Application for Certification (15-AFC-01)

Puente Power Project (P3)
Oxnard, CA

Refinement to Ammonia Tank Design

February 2016

REVISED FIGURE 2.1-1

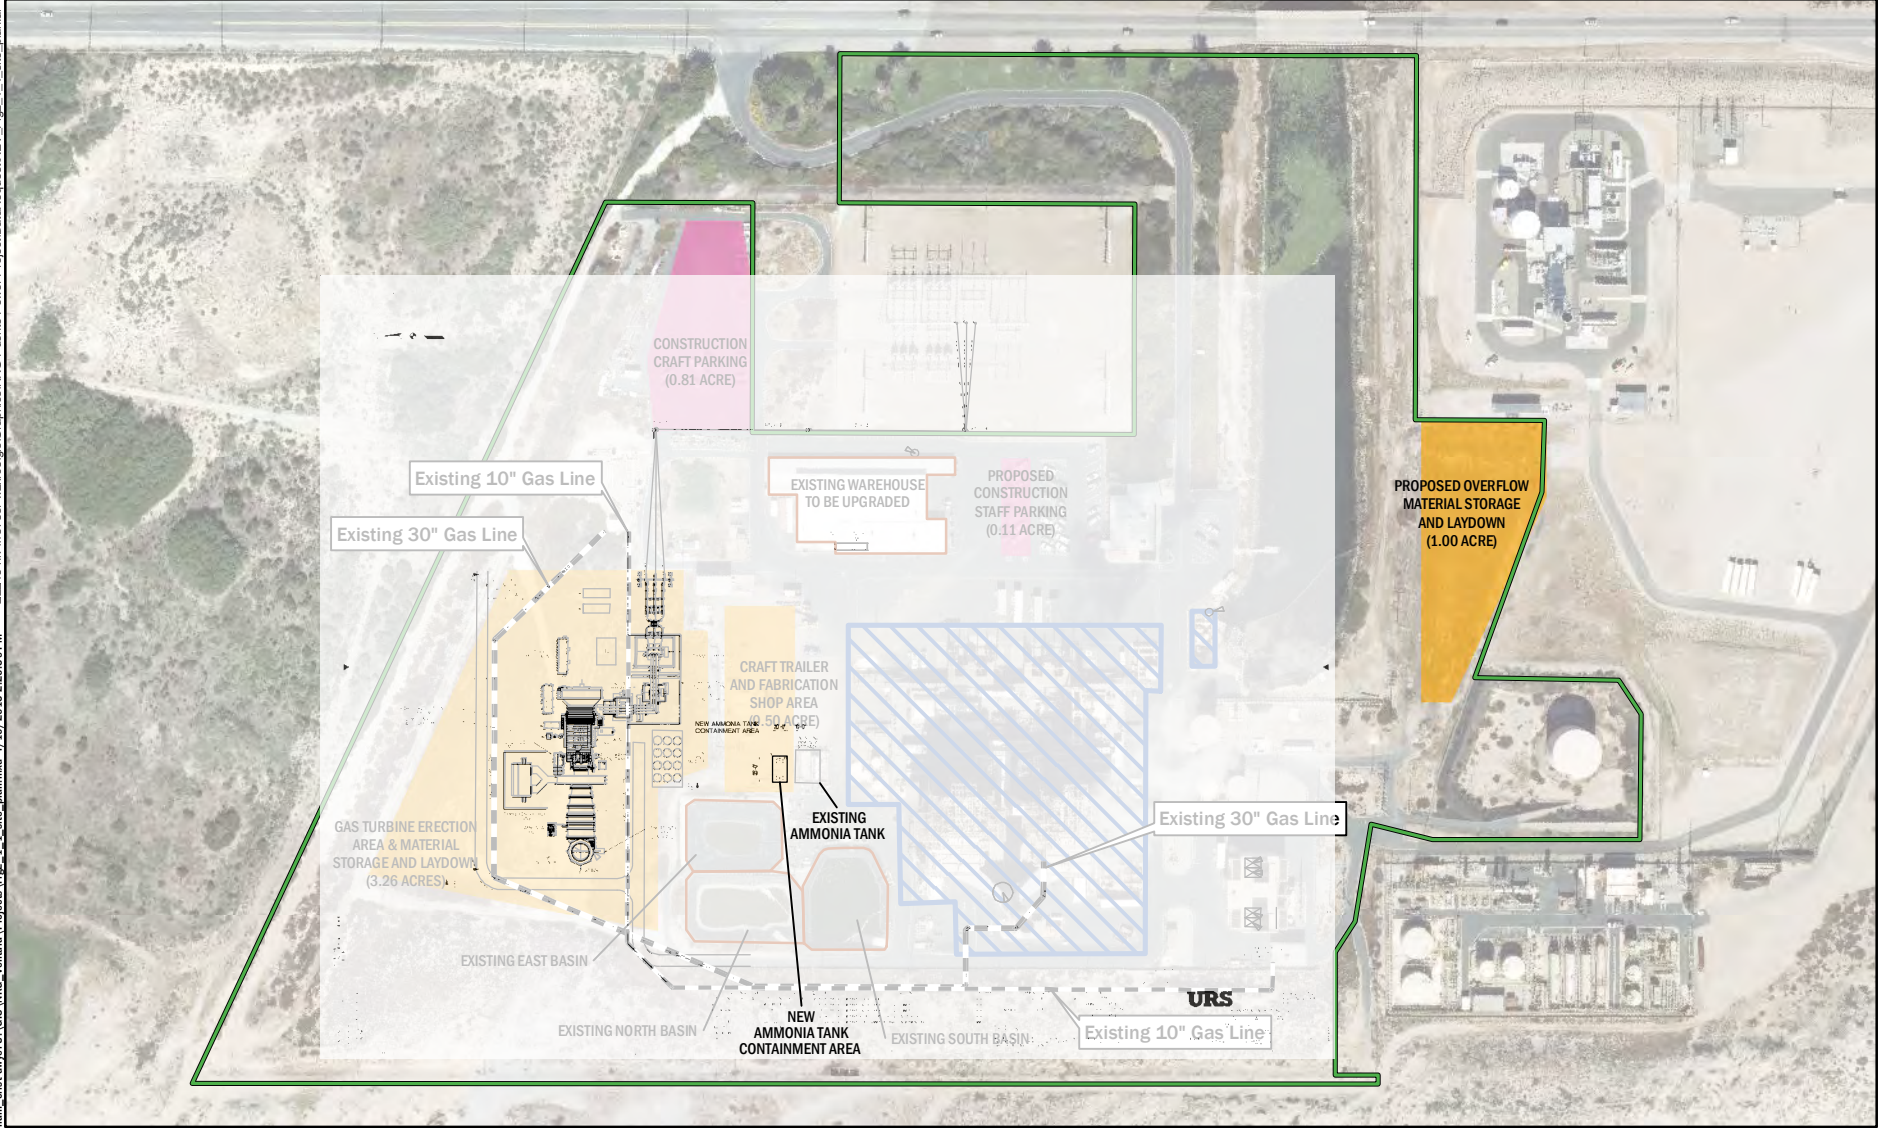
The following revised Application for Certification (AFC) figures, showing the revised location of the ammonia tank, are attached to this document:

- Revised Figure 2.1-1 Site Plan; and
- Revised Figure 2.7-1 Plot Plan.

REVISED FIGURE 4.5-1

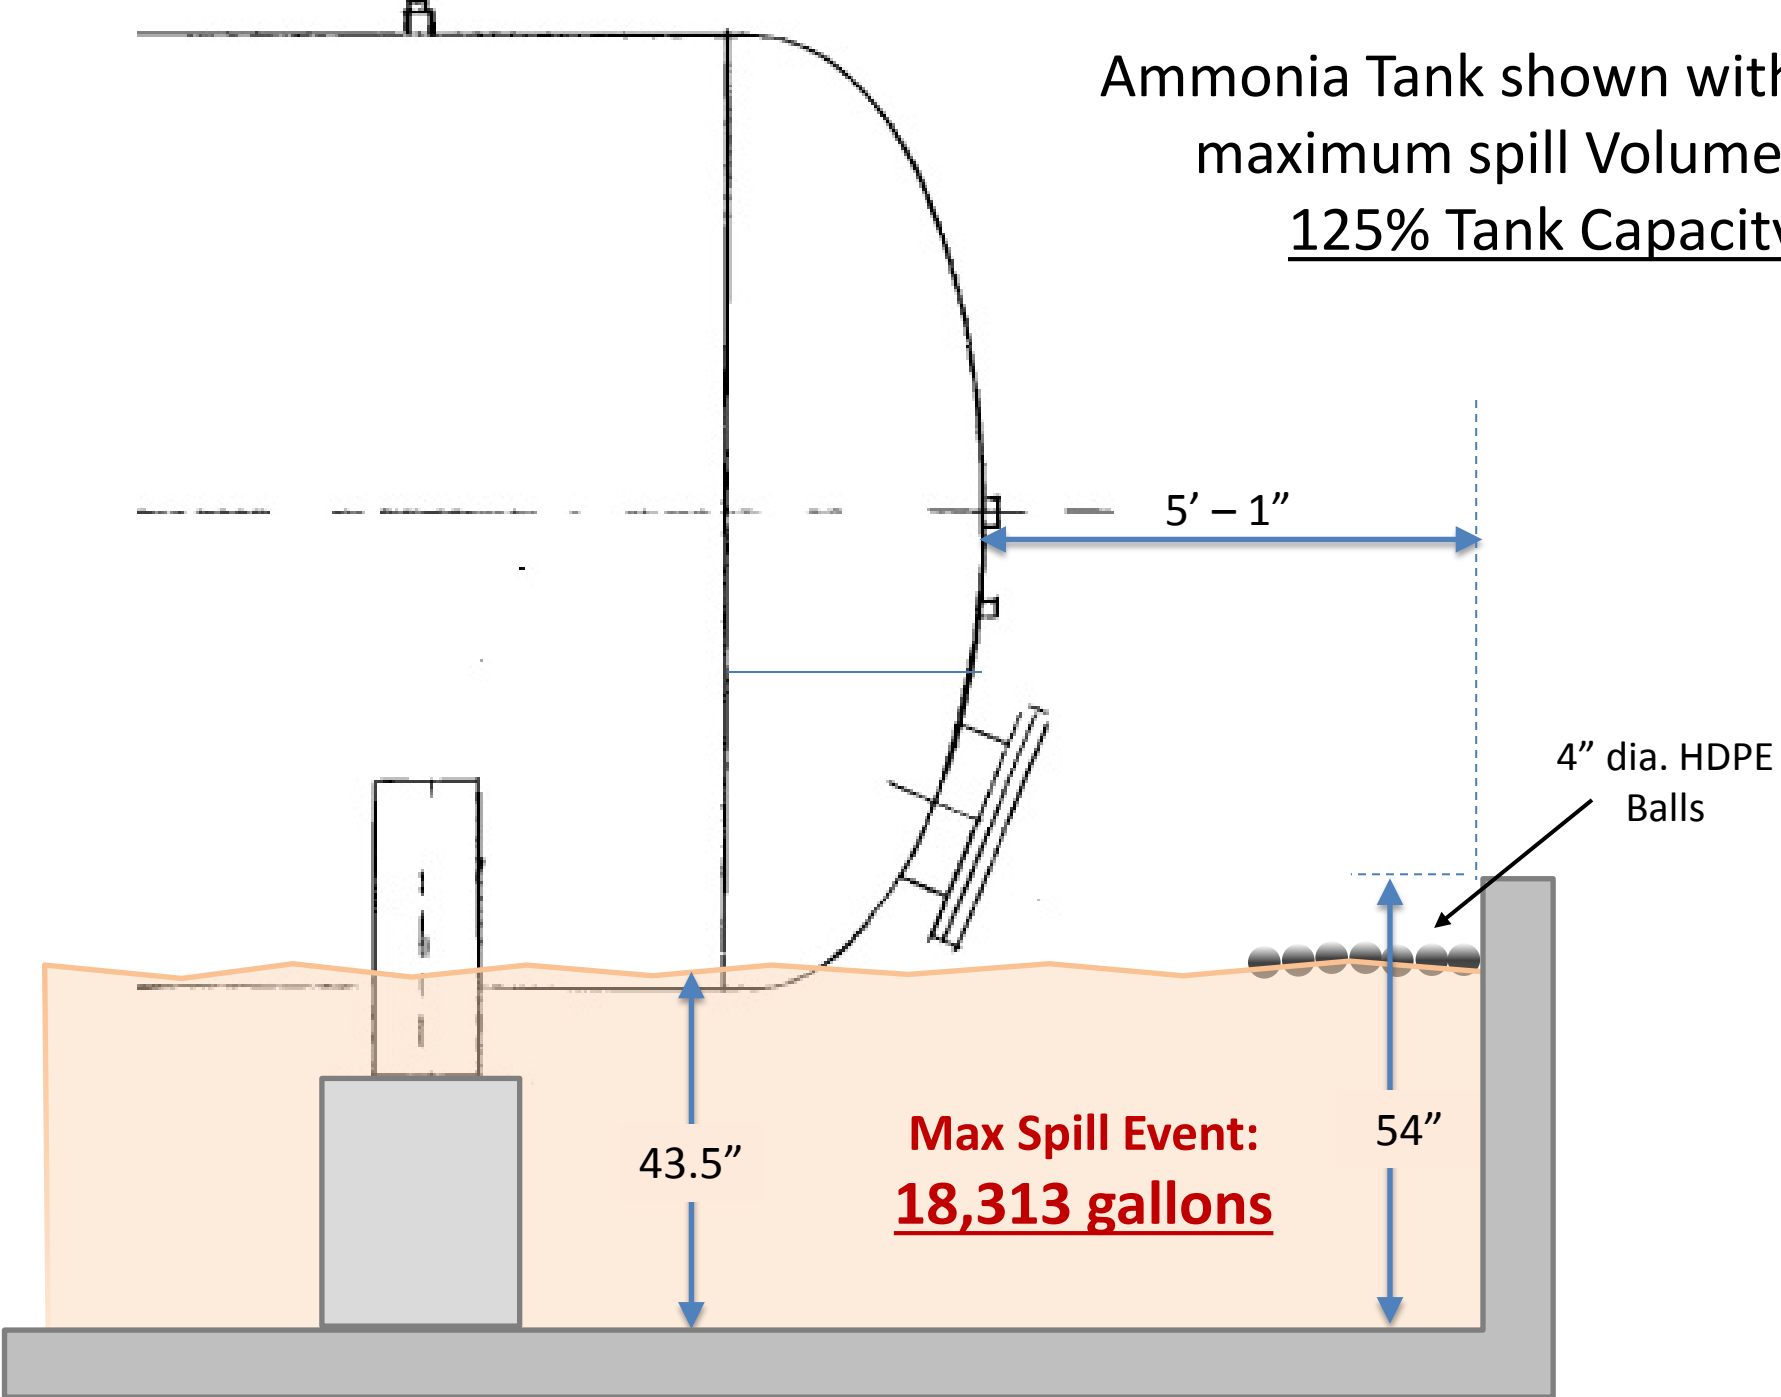
As shown on Revised Figure 4.5-1, the calculated threat zones for 75 ppm (California Energy Commission significance value), 150 ppm (Department of Transportation Emergency Response Program Level 2 “ERPG-2”), and 200 ppm (U.S. EPA/California Accidental Release Prevention Program Toxic Endpoint) are shown below for both the AFC analysis and the analysis for the revised secondary containment design:

Note: Distances are same for 4" and 6" balls and one or two layers.
